**RESPONSE TO FREEDOM OF INFORMATION ACT (FOIA) REQUEST**

The record listed on Appendix N is copyrighted. Therefore, it is only being made available for inspection in the NRC Public Document Room.

NRC INSPECTION  
QUESTION/RESPONSE TRACKING FORM.

SIMPLIFIED CIRCUIT FOR  
DATA LOGGER AND RELAY DRIVER CARDS

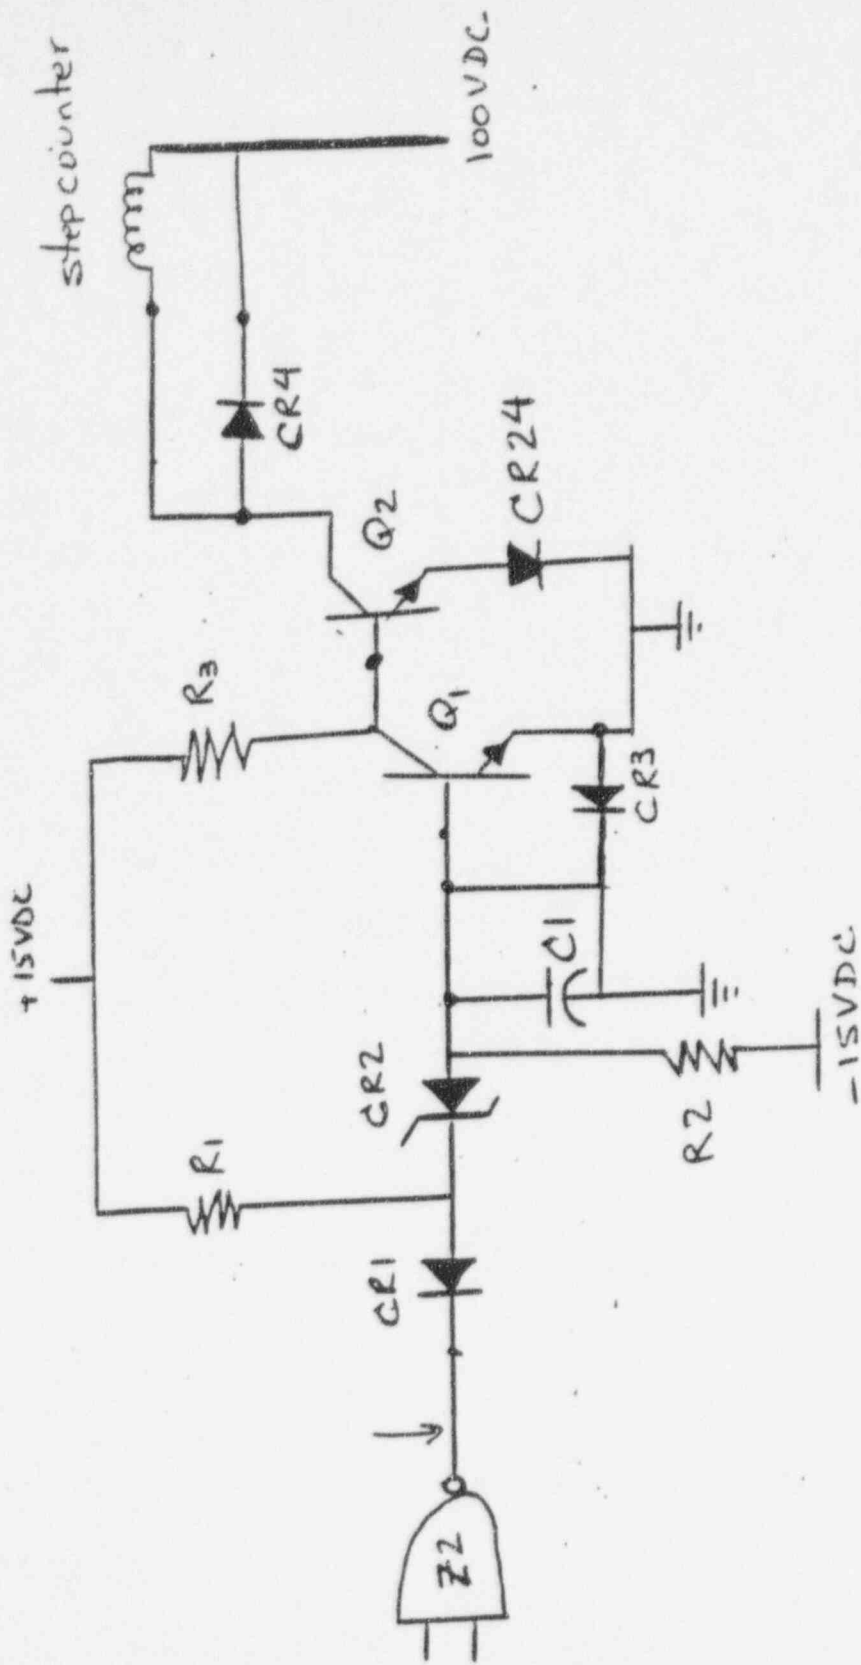
The circuit short from 100VDC to -15V through relay driver card is not a valid path and correct assumption, based on the fact that we have not experienced an

Based on event scenario and recorded information, possibility of 100VDC & -15VDC short circuited through any parts of the circuits is extremely low and indications are hard to miss. Therefore there must be an external element to 100VDC and -15VDC short circuit theory.

DETAIL-F

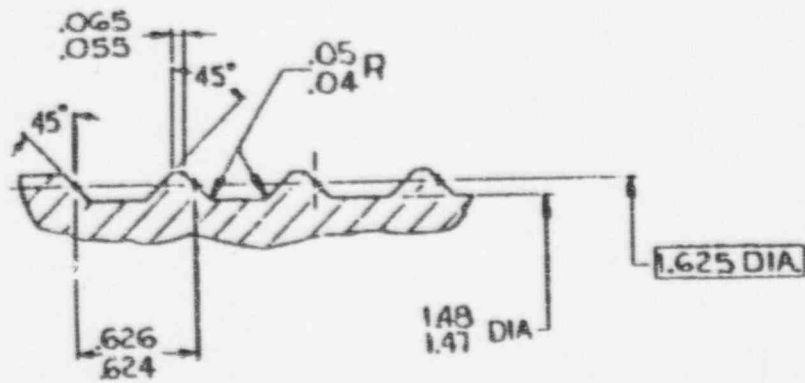
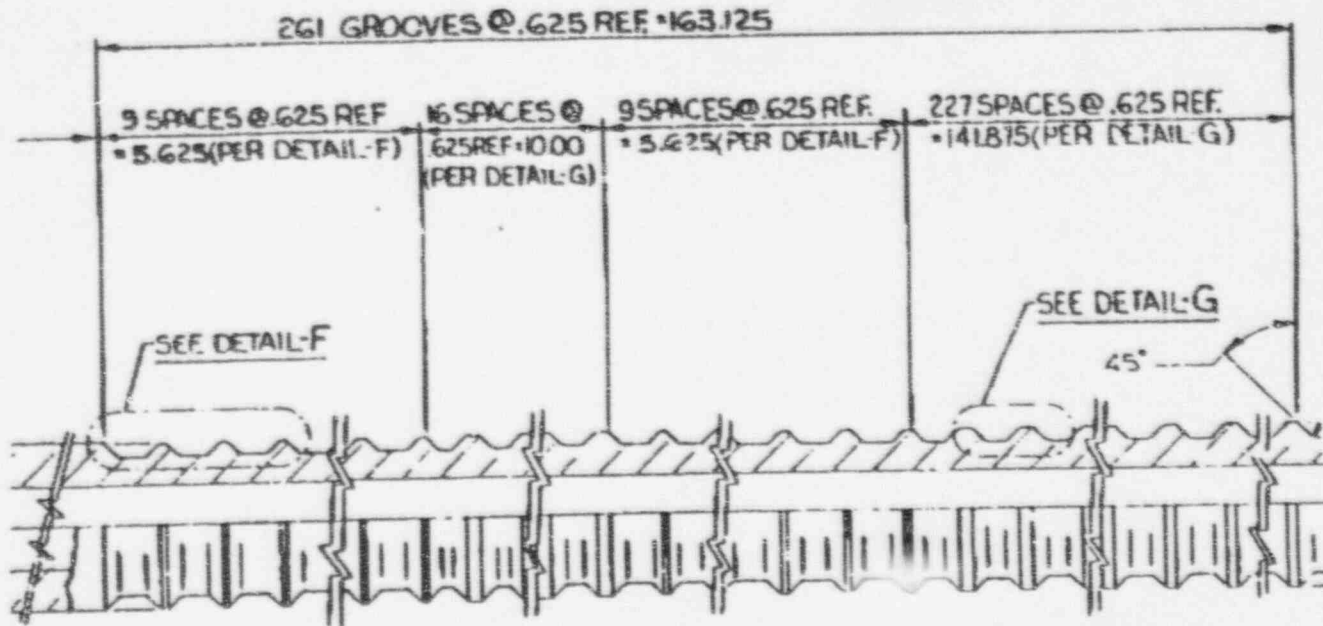
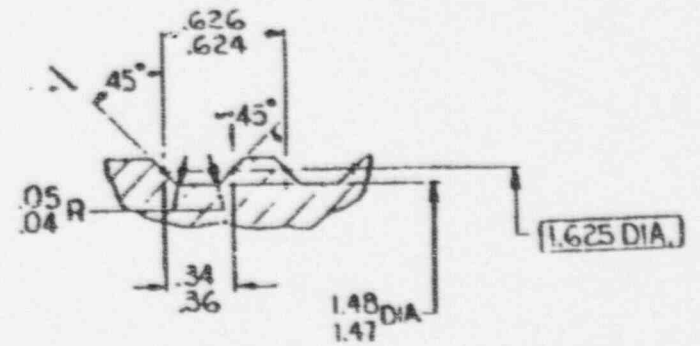
QUESTION: Provide drawing of lift rod and grippers, showing mechanical dimensions and tolerances. A force diagram of the above components, i.e. showing lift force of lift coil and spring/coil forces acting on movable + stationary grippers

FIG. 1  
S/N 12 PAD 6  
ELECTRICAL OVERSTRESS

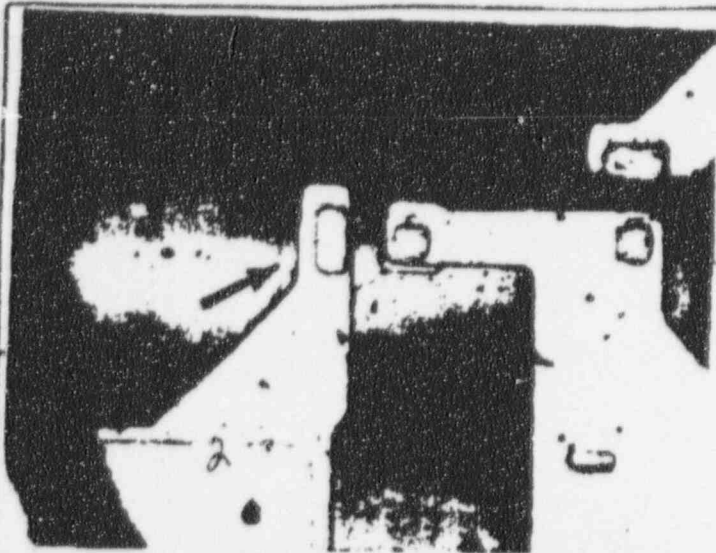
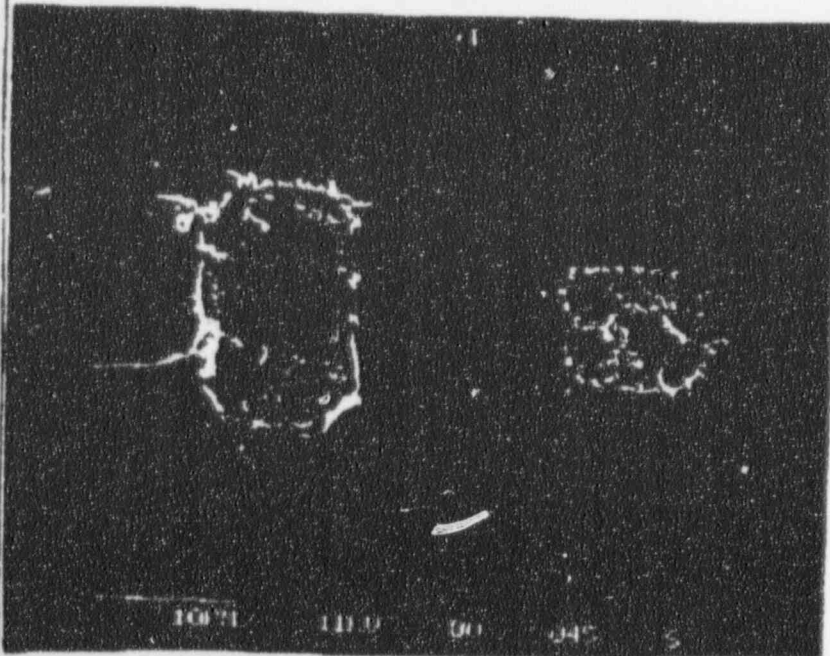
INDICATIONS OF ELECTRICAL  
OVERSTRESS DUE TO ESD

AFTER REMOVAL OF THE  
GLASSIVATION AND METAL,  
THE OVERSTRESS IS SEEN  
MORE CLEARLY

AFTER DEPROCESSING  
TO SILICON, SEM  
EXAMINATION SHOWS  
THE OVERSTRESS.

Attachment 4  
Alarm Card - schematic

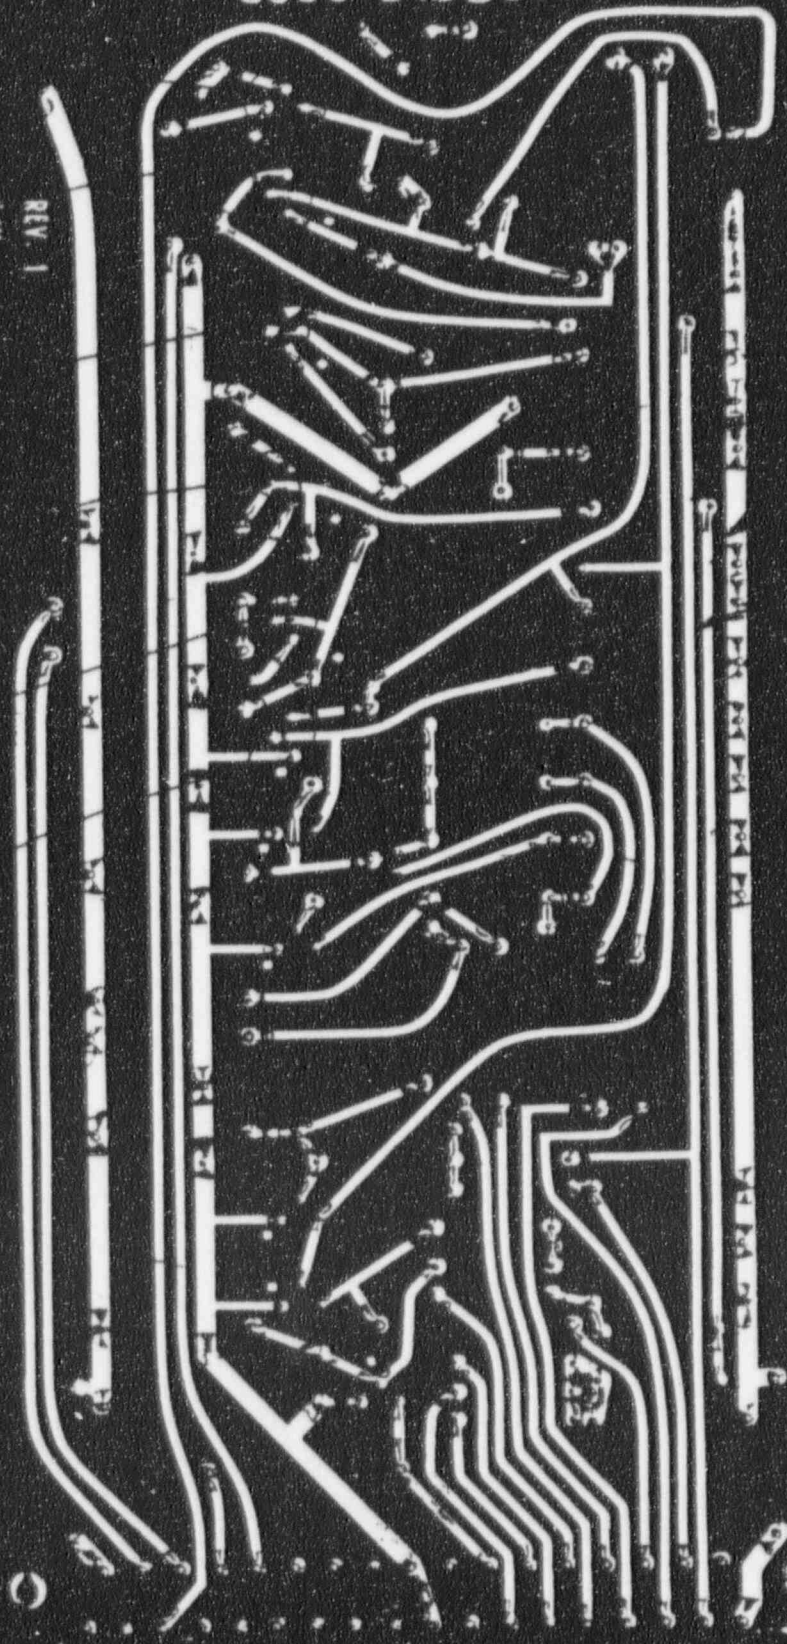
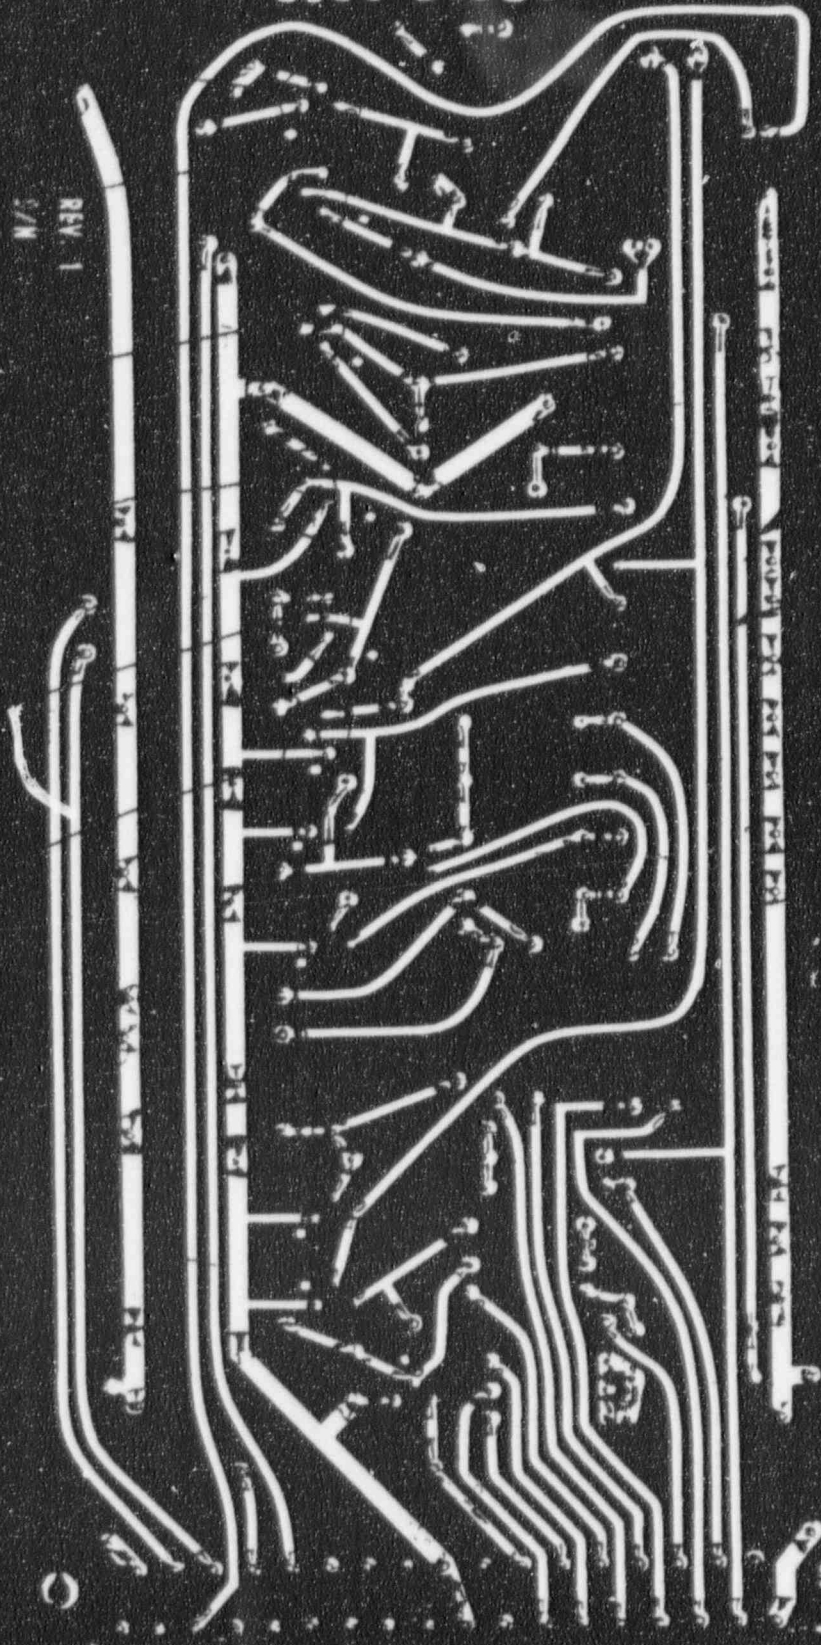
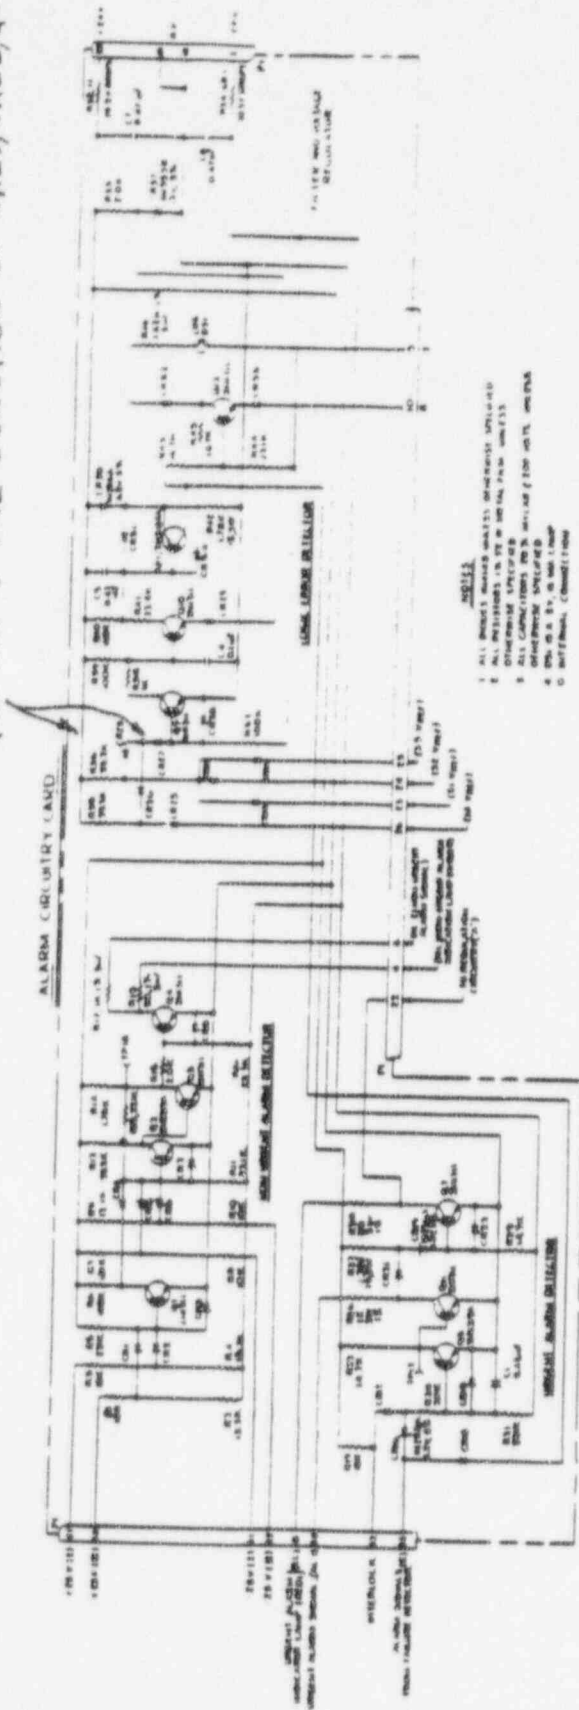
The failure of the Alarm Circuitry card noted will not allow logic error detection.

SHORTING OF TWO TRACES  
 DESCRIBED IN TEXT JUMPERS  
 +24VDC TO THE ANODE OF CR27  
 (WHICH IS THE JUNCTION OF CR25, CR26, & CR27)
